Access Compliance Report Public Rights-of-Way (Curb Ramps)

Main Street: EPONA_WAY Cross Street: ILLUMINATA_LN Location: E

ADA ID: RPRK211027141622 Ramp Type: Type 4 - Parallel Initial Pass/Fail: Pass Overall Compliance: No Severity Score: 20

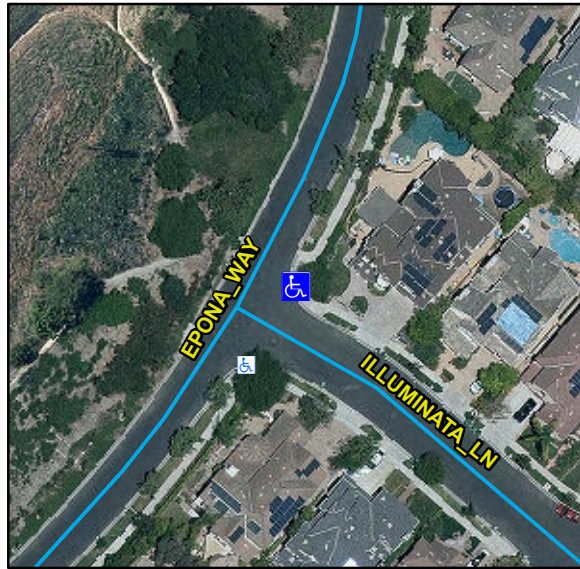
Surveyor Notes:

N/A

Possible Solutions:

Remove & Replace Curb Ramp With Two New Directional Ramps or Equivalent.
